TM 11-5820-398-35

FIELD AND DEPOT MAINTENANCE MANUAL RADIO SET AN/PRC-25

CHANGE }
No. 1 }

TM 11-5820-398-35, 8 January 1963, is changed as follows:

Page 14, figure 5. Make the following changes:

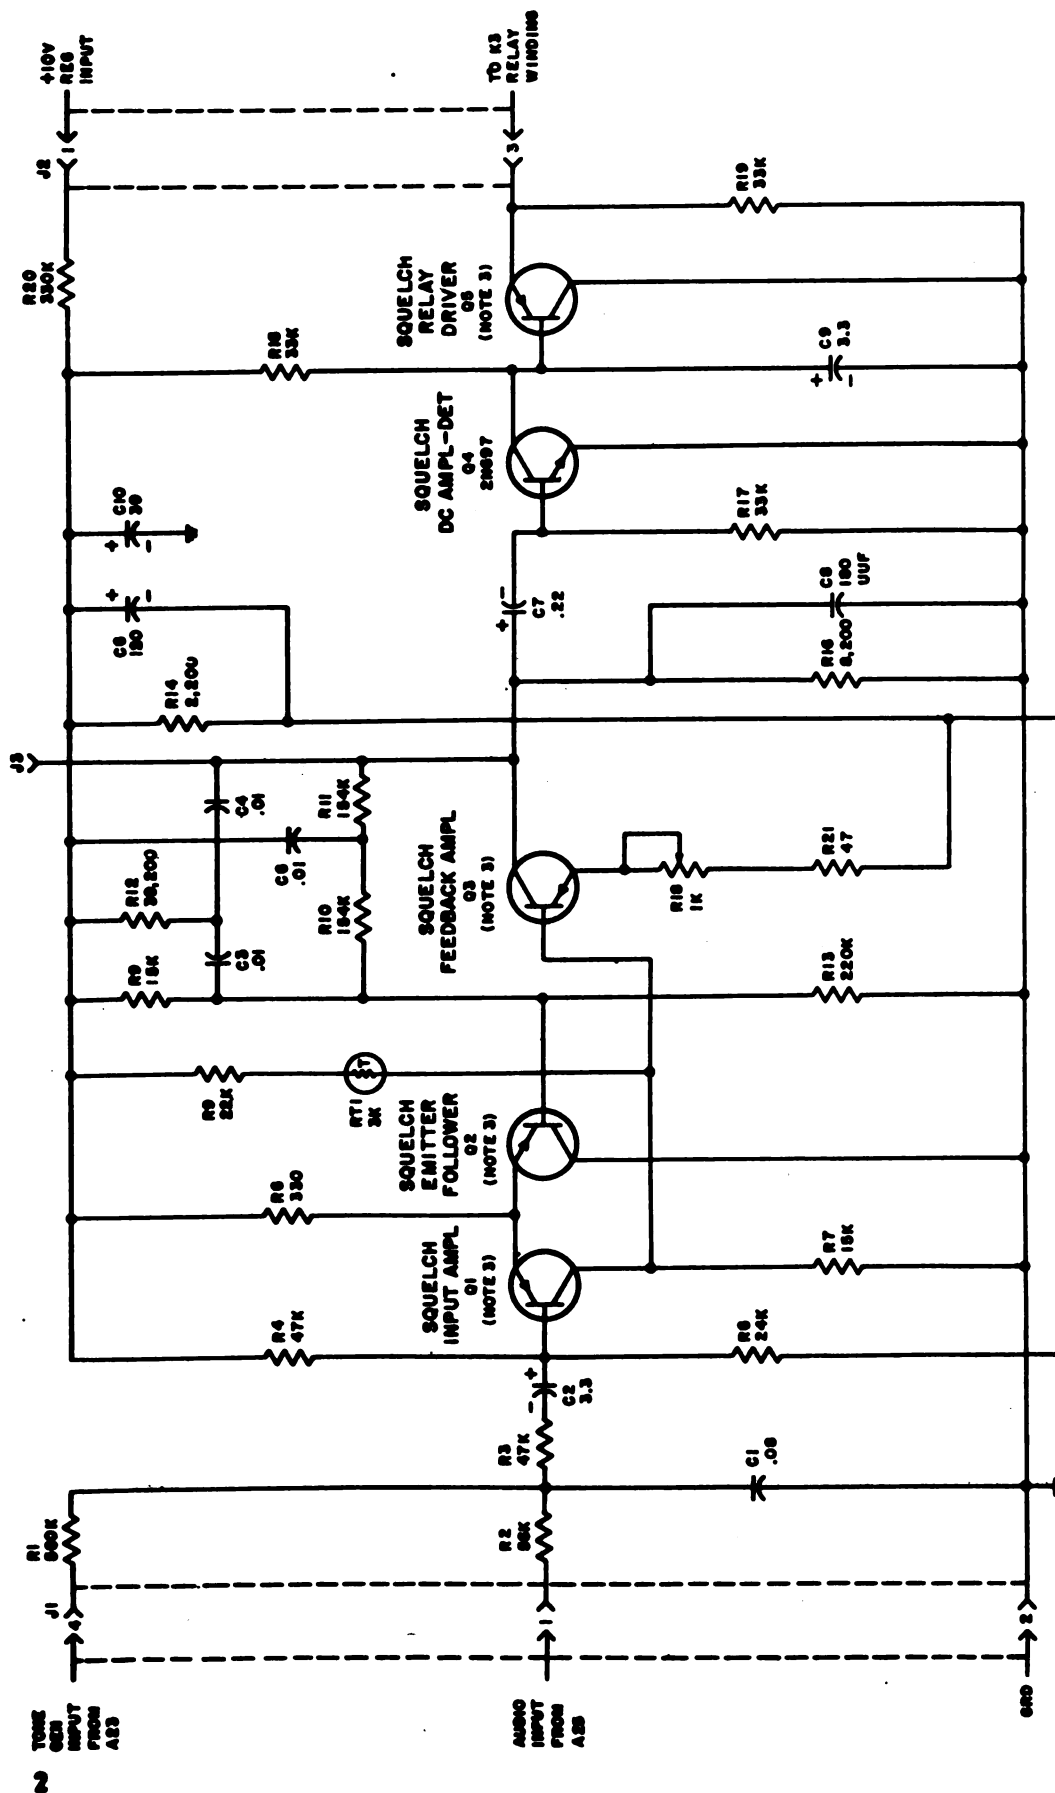
Change the value of C7 from .1 to 0.22 μ f.

Delete the connection between the emitter of Q5 and the +10V regulated input.

Near R12, add: (NOTE 5).

Change the figure caption to *Tone squelch module A24, early model, schematic diagram.*

Figure 25.1. *Voltage regulator module A16, late model, schematic diagram.*

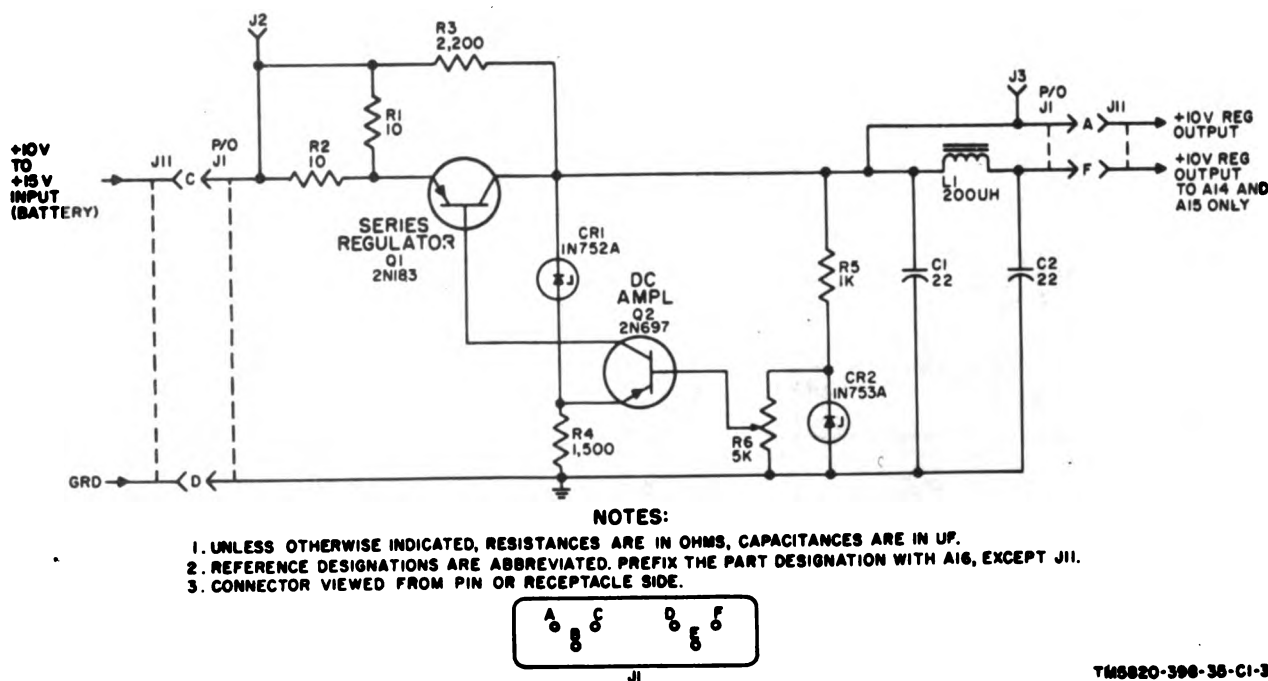
Paragraph 80. After the last sentence of the paragraph, add: In late models (fig. 25.1), potentiometer R6 is connected across CR2 to permit adjustment of the voltage applied to the base of Q2. This provides a fine adjustment of the regulated output voltage.

Page 38, figure 25. Change the figure caption to: *Voltage regulator module A16, early model, schematic diagram.*

Add figure 25.1 after figure 25.

Figure 68.1. *Module A16, late model, parts location.*

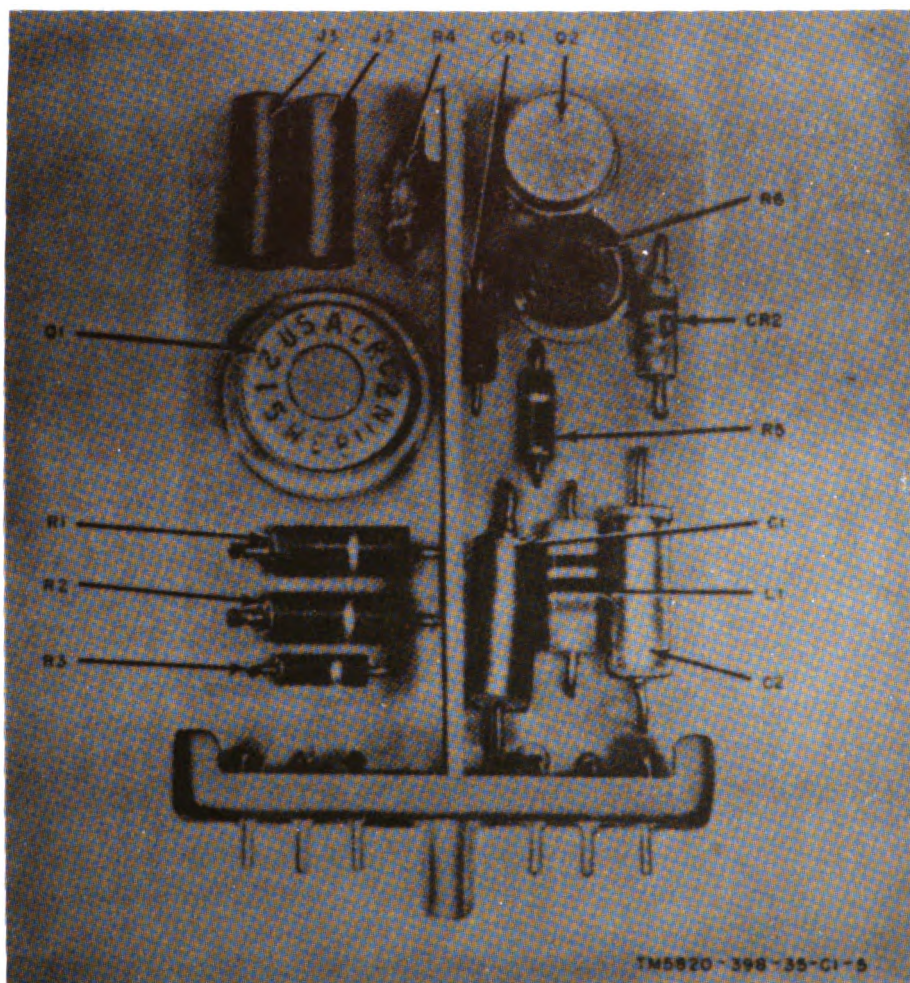
- (5) If the voltage measured in (3) above is incorrect in a late model module A16, adjust R6 (fig. 68.1) for the correct output voltage.

Figure 68, caption. Change the caption to:
Module A16, early model, parts location.

Add figure 68.1 after figure 68.

Figure 70.1. *Module A18, late model, parts location.*

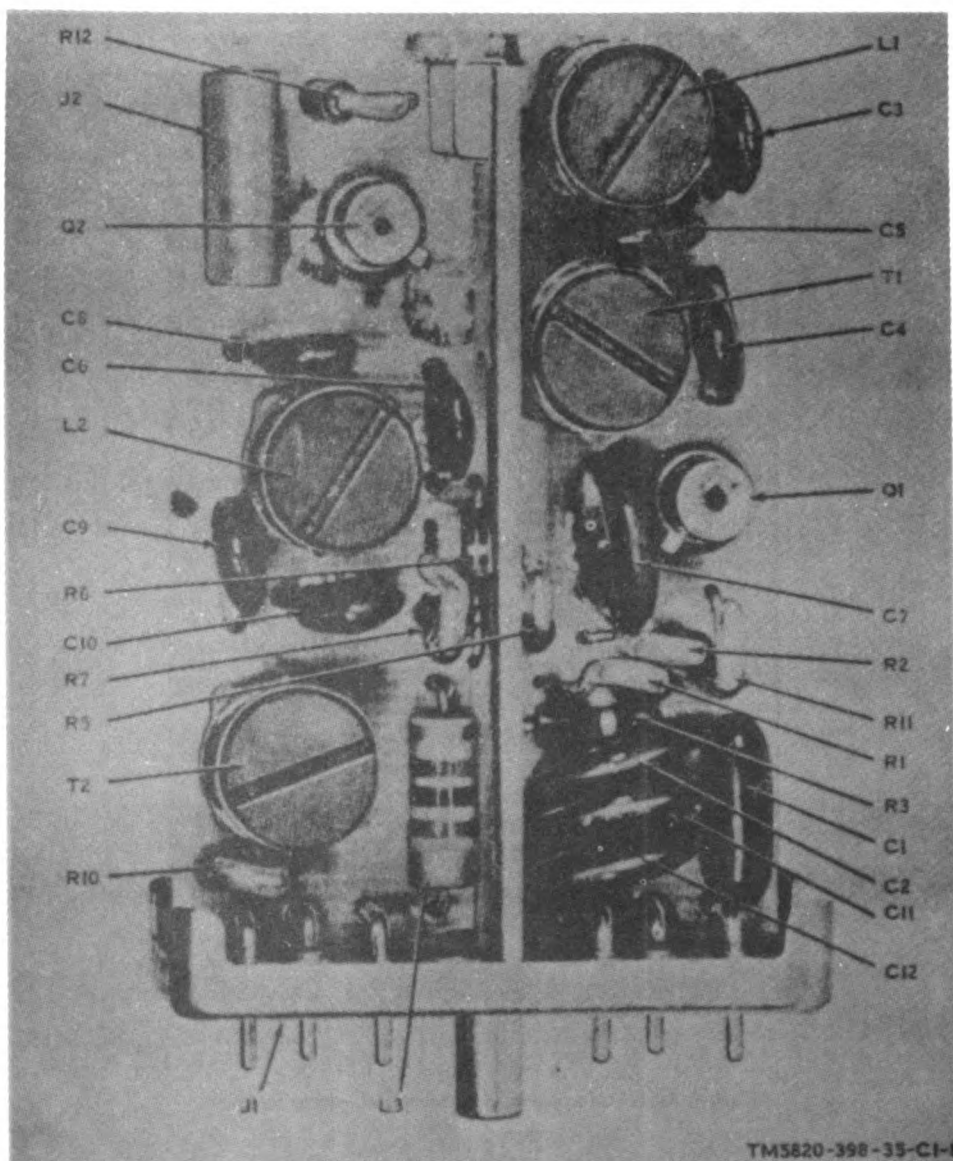
Page 135, figure 70, caption. Change the figure caption to: *Module A18, early model, parts location.*

Add figure 70.1 after figure 70.

Figure 75. Module A23, early model, parts location.

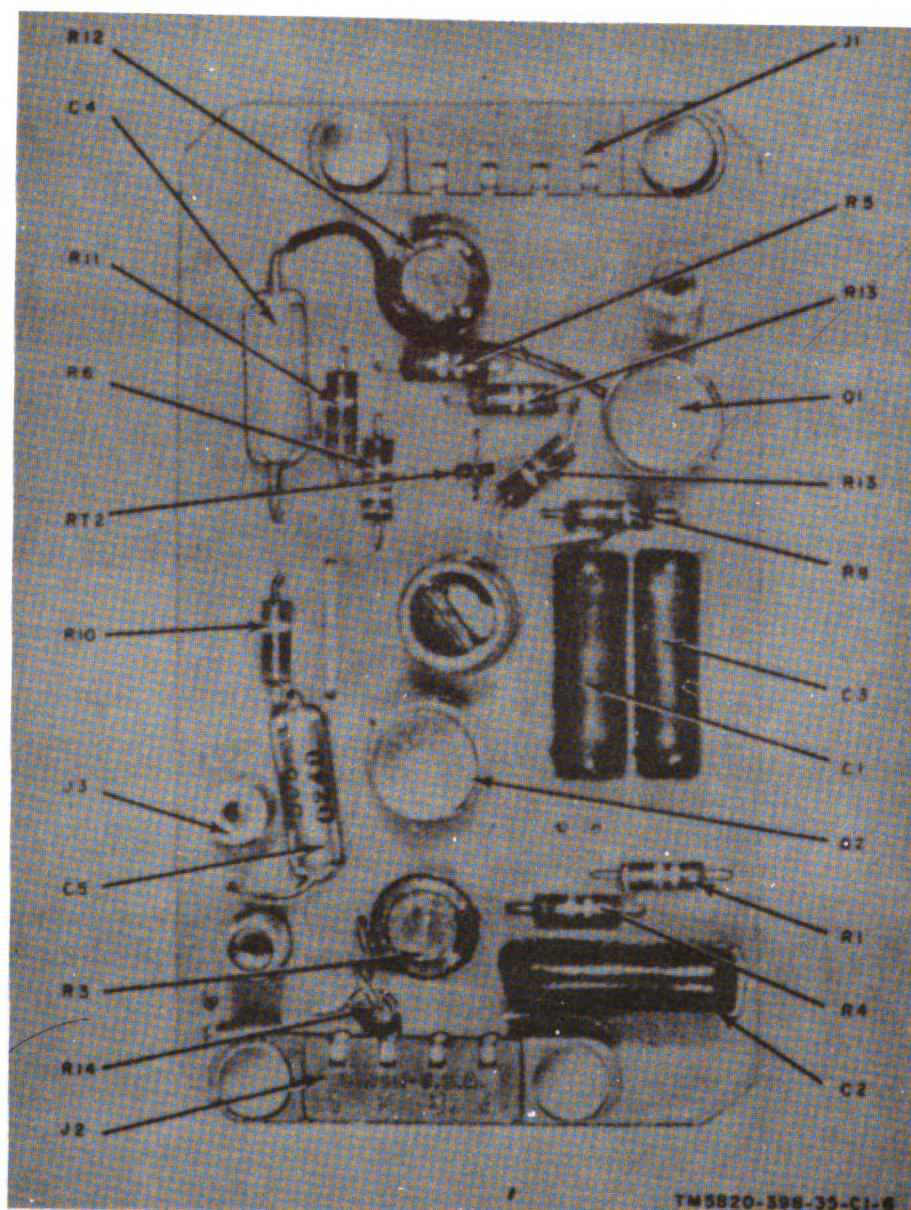
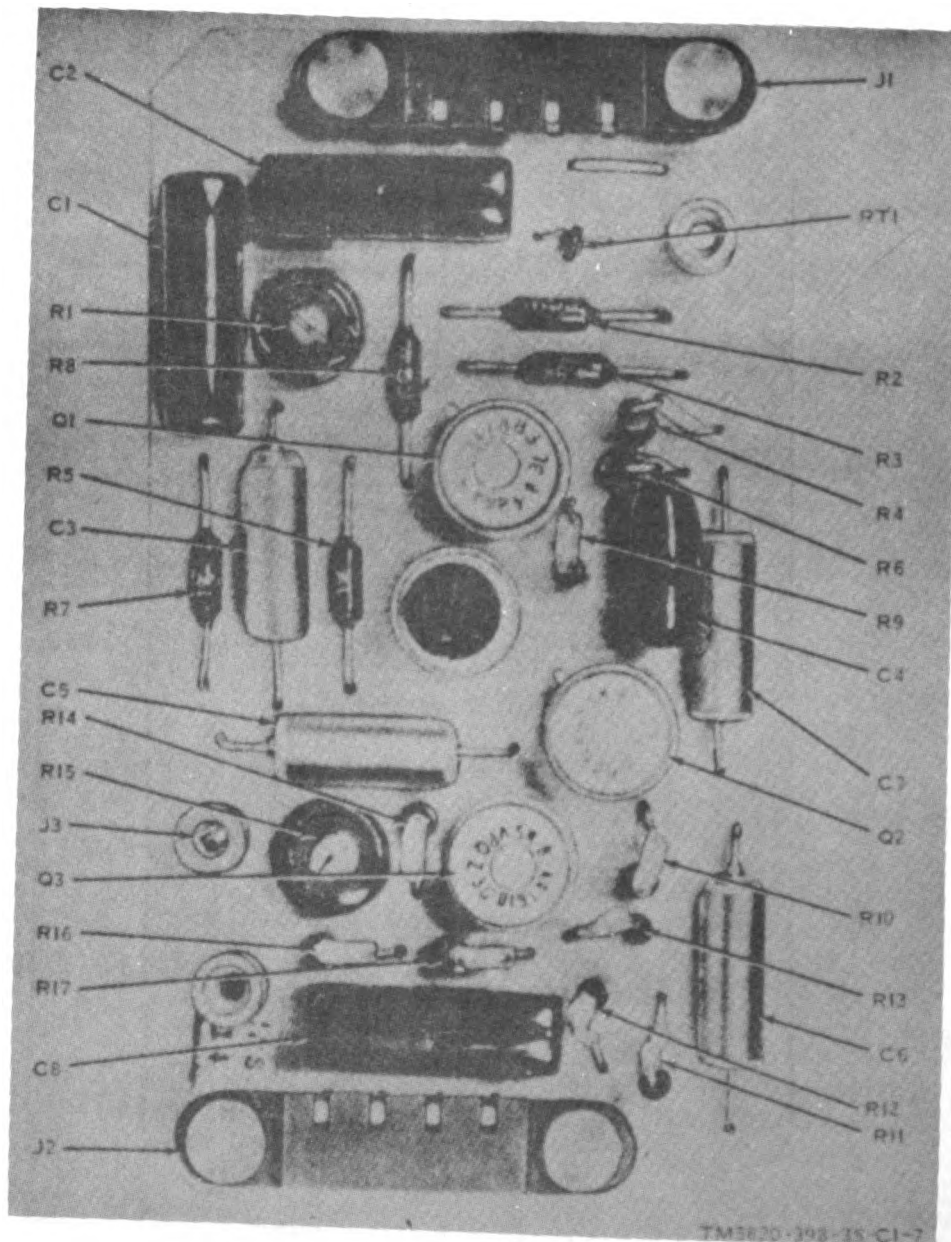
Page 142, figure 75. Delete figure 75 and substitute new figure 75.

Add figure 75.1 after figure 75.

Figure 10.1. Variable frequency oscillator A9, Order No. 64009-PP-63, improved schematic diagram.

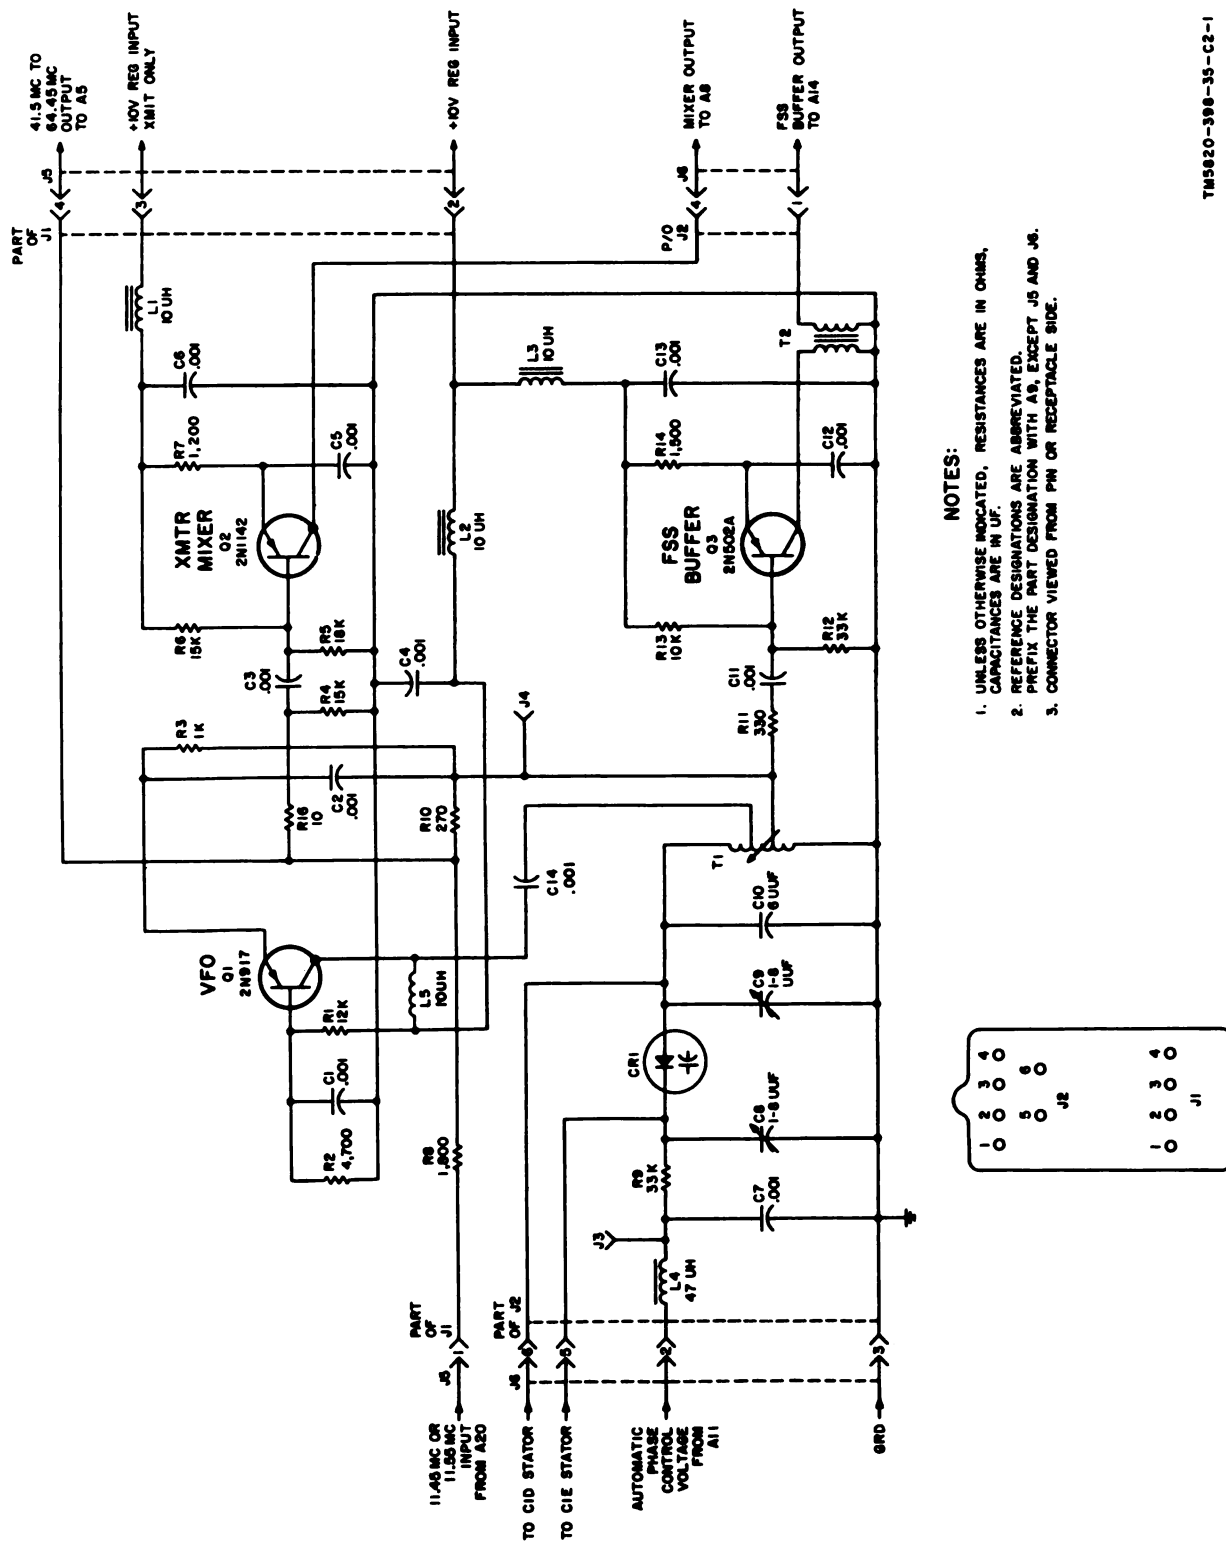
Page 14, figure 5.1 (page 2 of C 1). Make the following changes:

Near R12, add (NOTE 4).

After note 3, add note 4:

4. IN LATER EQUIPMENT BEARING ORDER NO. 64009-PP-63, THE VALUE OF R12 HAS BEEN FACTORY SELECTED AND MAY BE 37.4K, 38.3K, OR 39.2K $\pm 1\%$.

Figure 61.1. Module A9, Order No. 84009-PP-83, improved module, parts location.

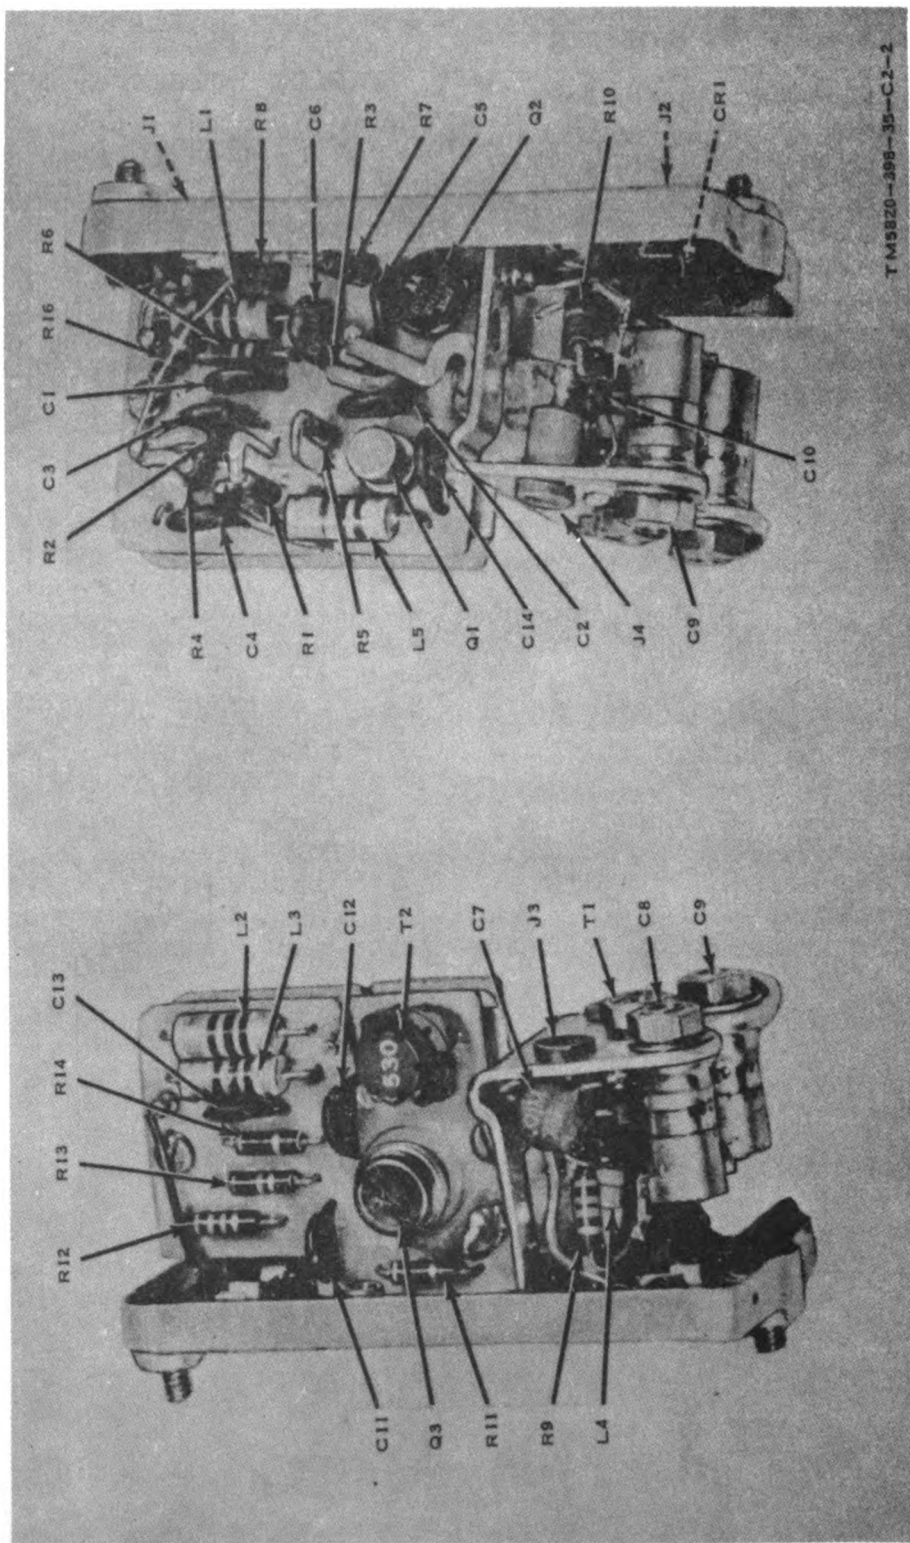
Page 124, figure 61. Add figure 61.1 after figure 61:
